B9- New Paper Mill

RESPONSE TO SUBMISSIONS FROM EXHIBITION OF ENVIRONMENTAL ASSESSMENT REPORT

- Modification #2 - Changes in Site Layout & Subdivision
- Final
- May 2010

- Final
- May 2010

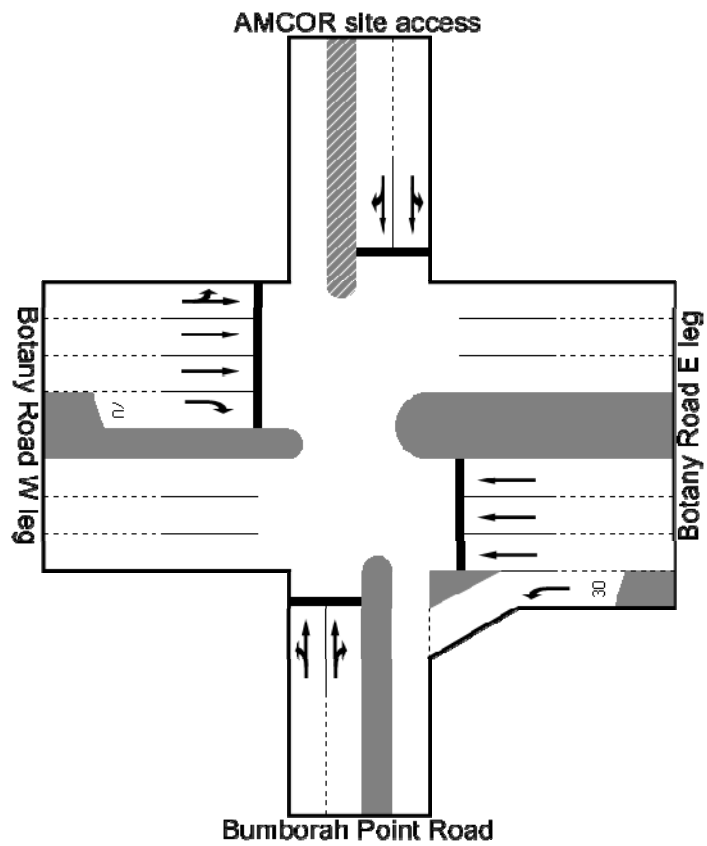
Submission #1 commented on Figure 3 of the Modification #2 Environmental Assessment Report that shows a 5.2m vehicle turning right on to McCauley Street from the proposed access at McCauley Street/ Raymond Avenue. This traffic movement was placed on the figure at the request of one of the government stakeholders and is a legal traffic movement. However all of AMCOR's vehicles would turn left only out of the site onto McCauley Street.

It is stated in "B9 Project - New Paper Mill – Revised Modification #2, ENVIRONMENTAL ASSESSMENT REPORT" (the Report) that vehicles will only turn south into McCauley Street, however in *Figure 3 Upgrade of McCauley Street* (pg. 22) it clearly shows there is provision in for vehicles of 5.2m to turn right into McCauley Street and therefore into Australia Avenue and Harold Street. The Report also states all employee, visitor and contractor vehicles will exit via Botany Road, however there is no provision in *Figure 2 Modified Site Layout* (pg. 21) for vehicles to turn out of the car park and exit to Botany Road.

It should be noted that AMCOR is only applying for approval for B-Doubles to use the southbound lane of McCauley Street.

Minor modifications of the kerb and traffic islands at the McCauley Street/ Botany Road intersection would be required.
